ALTAMONT ZONING BOARD OF APPEALS
Regular Meeting Agenda
February 27, 2024
Altamont Community Room – 7:00 p.m.

**LANDS OF CM FOX LIVING SOLUTIONS LLC
MAJOR SUBDIVISION**

Re: CM Fox 11 Lot Subdivision Project – Comment Letter

CM FOX LIVING SOLUTIONS LLC
MAJOR SUBDIVISION
EROSION & SEDIMENT CONTROL PLAN
SHEET 5 OF 10
C-120

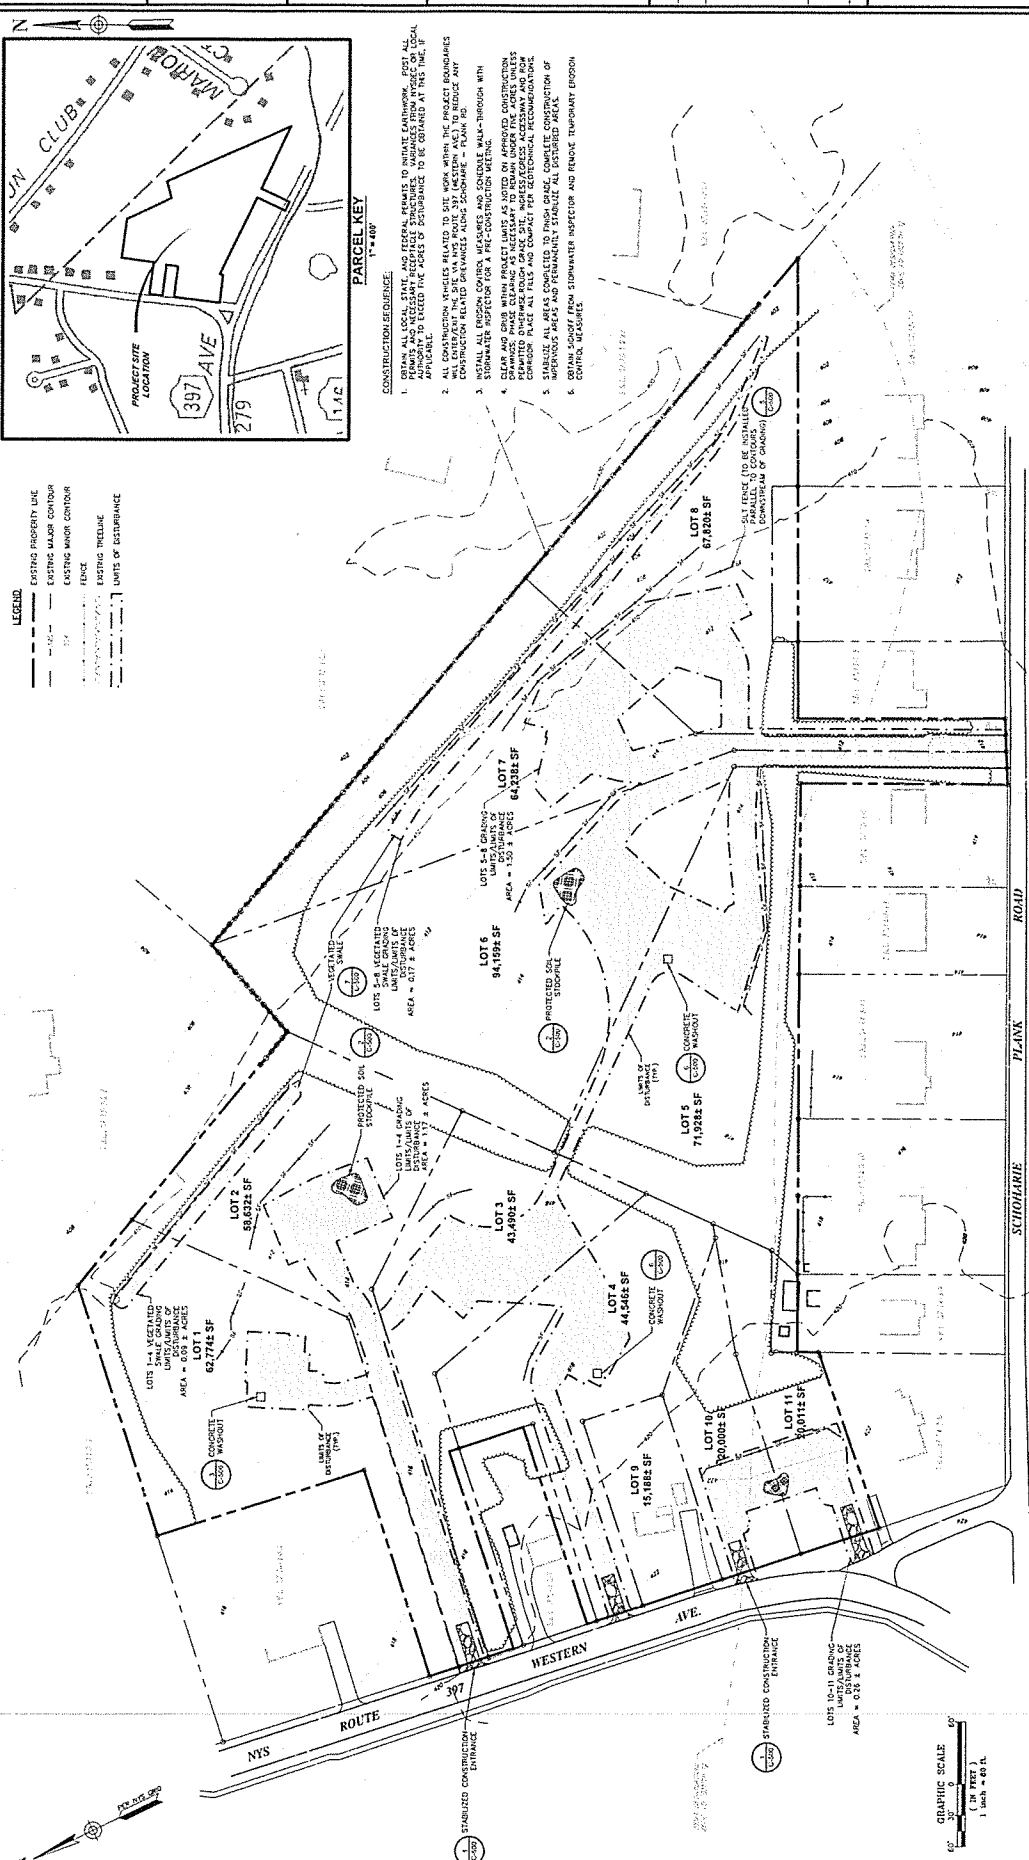
1. What are Geo-technical engineer recommendations mentioned in note 4 of Construction Sequence? Include in plans if pertinent.

A geo-technical engineer shall be consulted if and only if areas of significant material fills were present on site, as designed no such areas are present on site.

GRADING & DRAINAGE PLAN	M FOX LIVING SOLUTIONS LLC	MAJOR SUBDIVISION	139 WESTERN AVE. S.W. 37164-6151	ALBANY COUNTY	NEW YORK STATE
-------------------------	----------------------------	-------------------	-------------------------------------	---------------	----------------

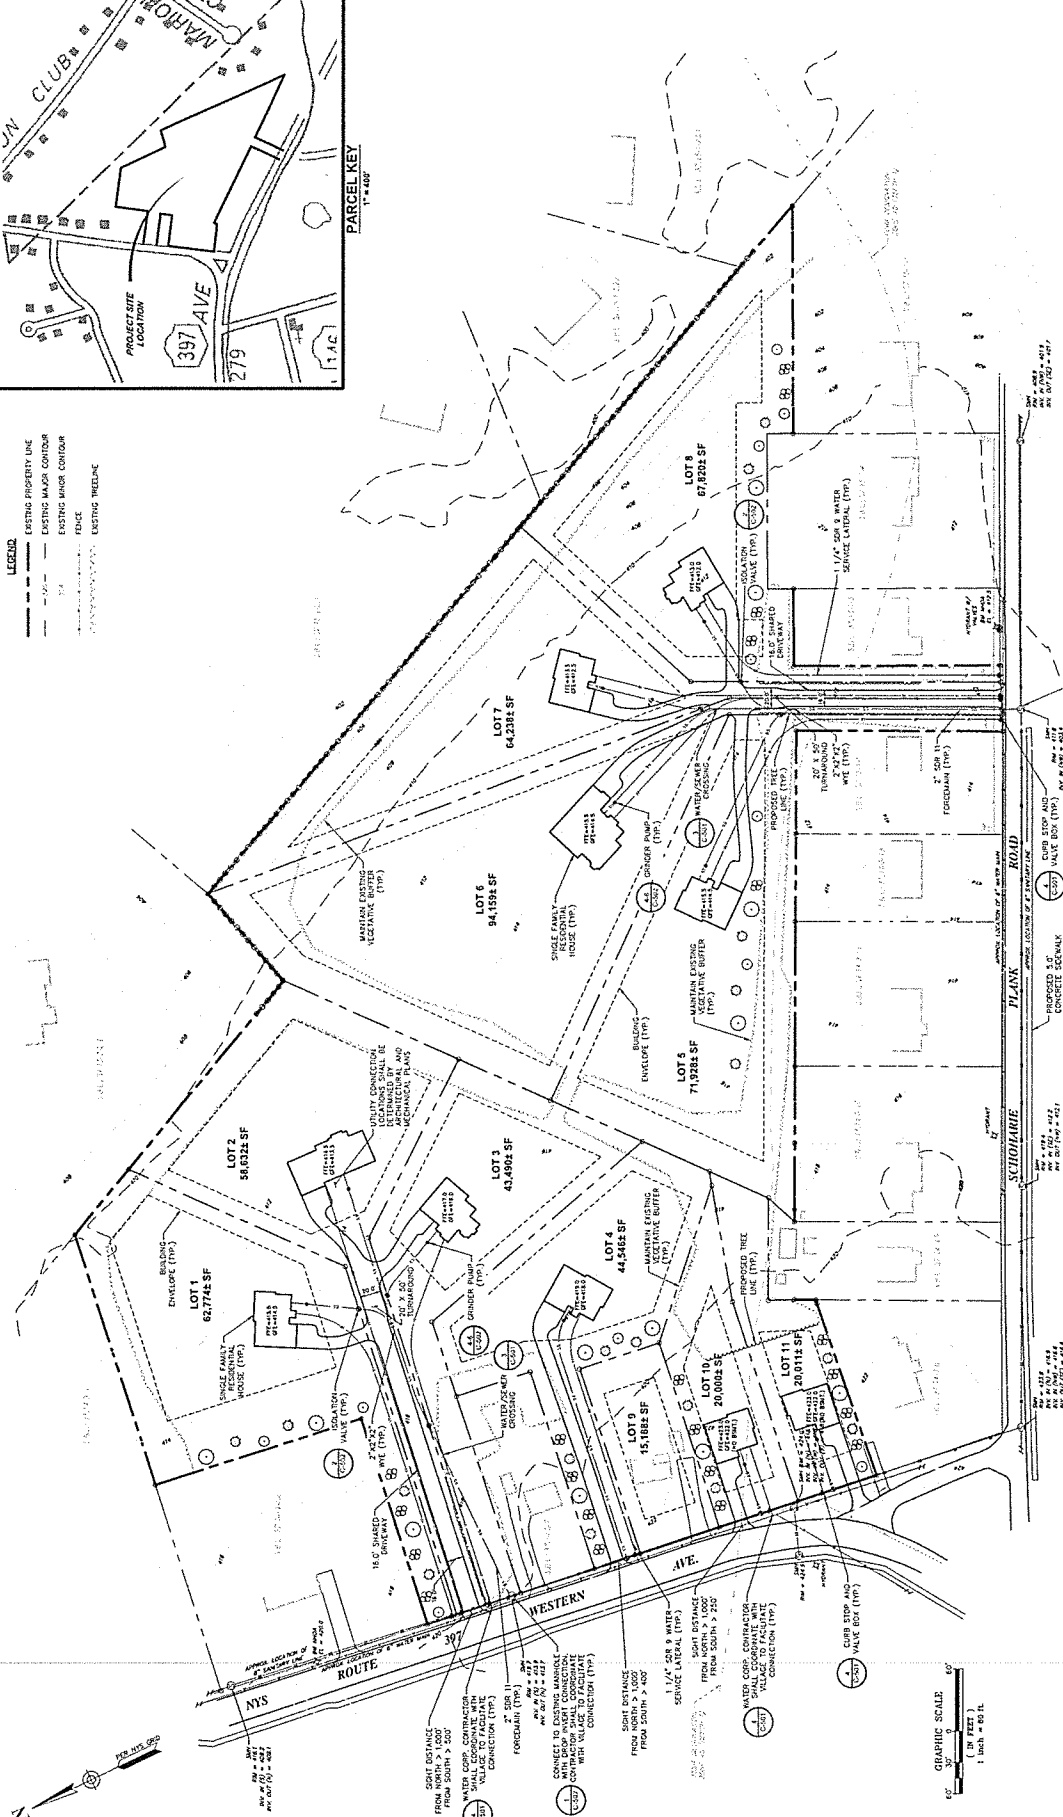
2. Indicate proposed drainage swale end elevations at north and south ends adjacent to Marion Court property lines. Northerly channel needs a weir elevation to discharge.

3. Where are the rain gardens previously discussed to receive roof drainage on each of the lots? Their storage value was intended to offset increases of impervious area from development in this sensitive area. The smallest lots could have smaller rain gardens.

4. Drainage of the property generally runs from west to east (Western towards Marion). There are no provisions for driveway culverts or consistent swales shown on the grading plans that allow runoff conveyance or avoidance or run-on drainage from one property to another except at lots 7 and 8.

5. During site walk-through provision of underground stormwater chambers were discussed near the end of swale on lot 1 to infiltrate some runoff. Please provide (4 sections) of 12" high PE chambers below ditch invert connected by grated vertical pipe 3" above bottom of swale.

7. Widen out discharge end of eastern swale through lots 7 and 8. Contour 402 should be 20' wide at end on lot 8. We recommend mixing some wildflower seed mix with grass seed for this 20'x10' end area for providing an erosion resistant vegetated area at discharge.

10. Where are provisions of drainage for low area west of WSP driveways and connection to existing catch basin discussed during walk-through?

Please refer to sheet C-140 Grading & Drainage Plan, for information on drainage swale elevations.

Please refer to sheet C-140 Grading & Drainage Plan, for information on the rain gardens. Although interpreted as a practice that would be installed based on a per lot basis; vegetated rain gardens have been incorporated into the drawing set for the project.

Please refer to sheet C-140 Grading & Drainage Plan and sheet C-300 Driveway Cross Sections, as the addition of the individual best management practices aid in the mitigation of runoff conveyance to adjacent parcels. Site details highlight the minimal grading required to

Please refer to sheet C-140 Grading & Drainage Plan for the addition of the PE Chamber in the northerly swale.

Please refer to sheet C-140 Grading & Drainage Plan.

Please refer to sheet C-140 Grading & Drainage Plan for details of catch basin provisions.

PLAN & PROFILE

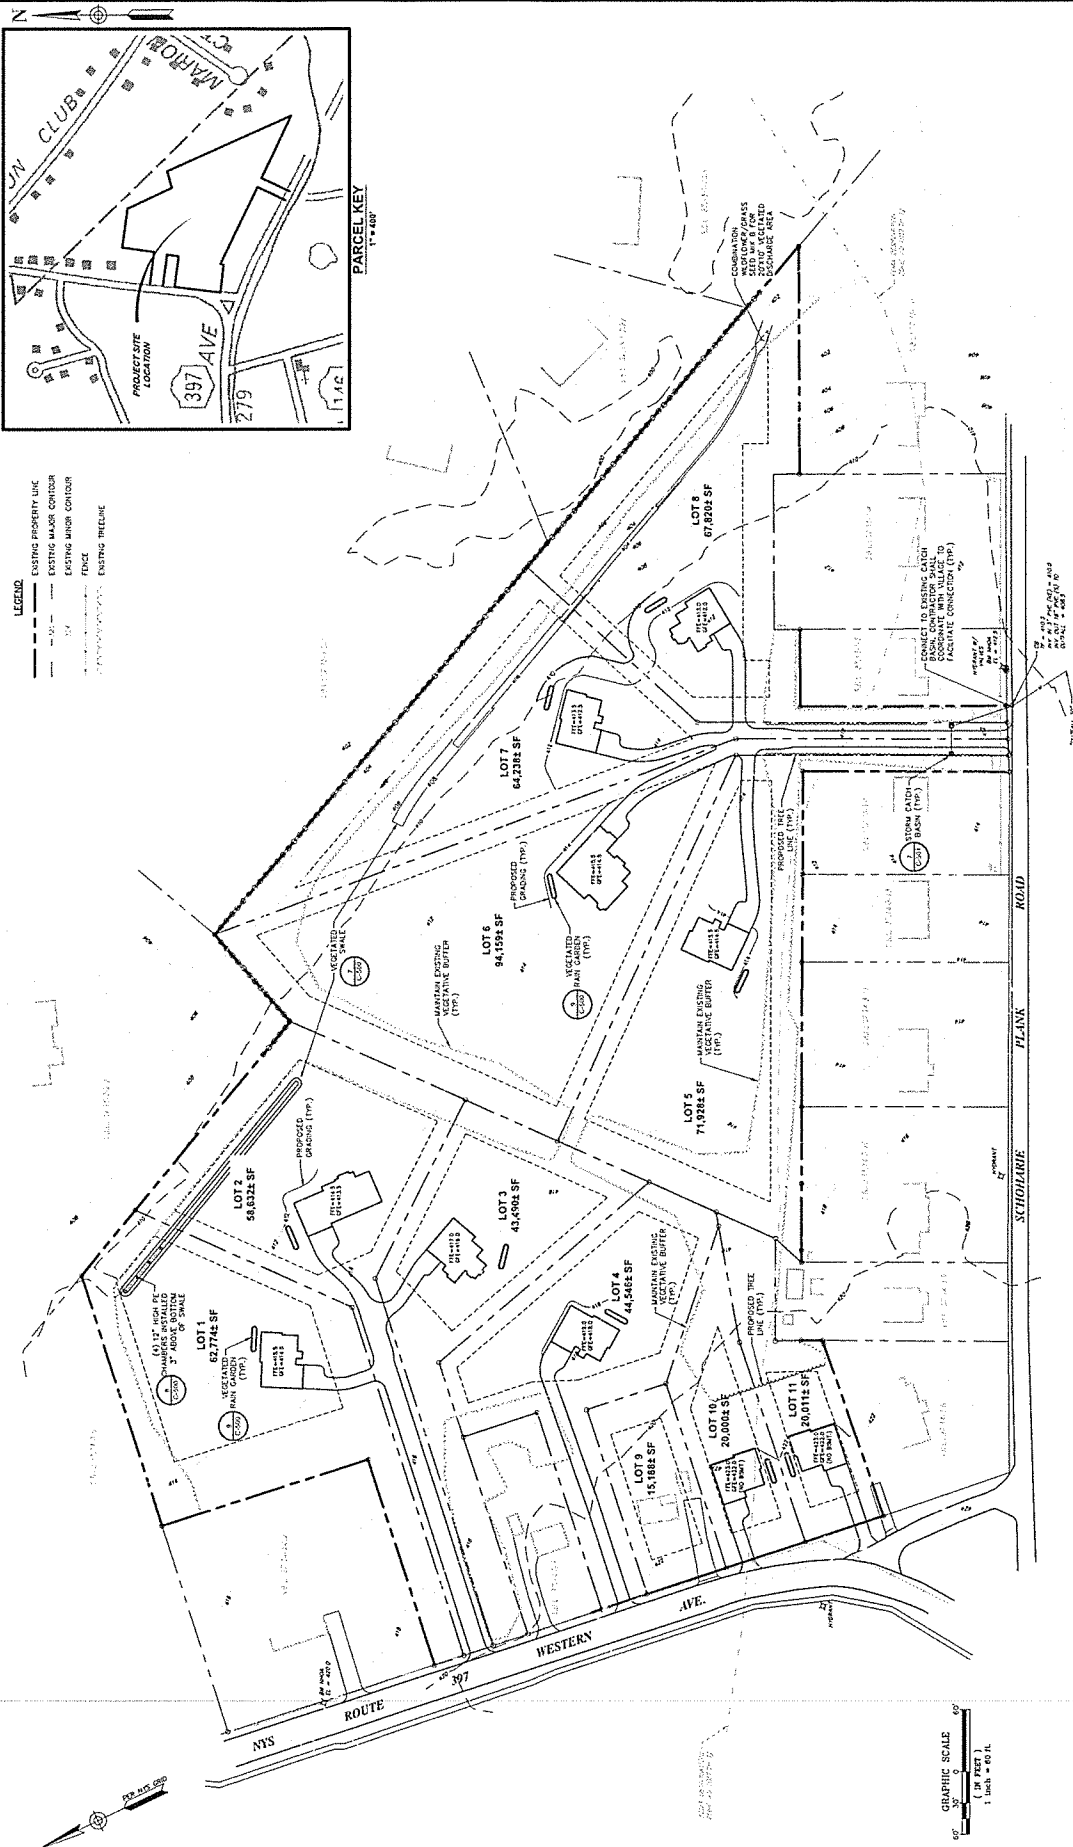
2. Provide a profile of each driveway that considers drainage, culverts and conveyance of runoff. Show water and sewer laterals with appropriate cover as already detailed.

Please refer to sheet C-150 Plan & Profile for utility information within common access driveway.
